SERVICE INFORMATION LETTER NO. 0101

Subject: Position and Strobe Light Assembly Light Shields

Models: 280 and 280C

VIEWED LOOKING AFT STROBE SHIELD
POSITION AND STROBE LIGHT ASSEMBLY WITH DIMENSIONS IN FLAT PATTERN

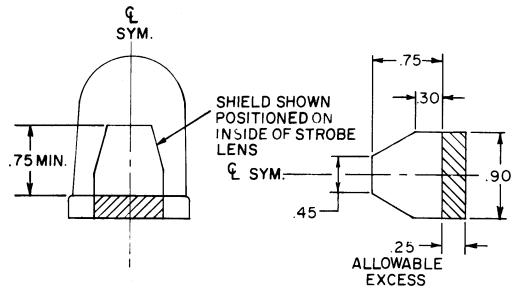
This shield, or mask, is installed to prevent forward strobe light penetration which can cause distracting reflections in the cockpit during operation. It is suggested that all owners and operators inspect both the left and right horizontal stabilizer strobe lights to verify the installation of the light shields. Units found without the proper shielding can be repaired in the field by removing and cleaning the strobe light lens before installing an aluminum foil pressure sensitive tape as illustrated.

NOTE: Be sure the tape is installed symmetrically on the forward side of the lens
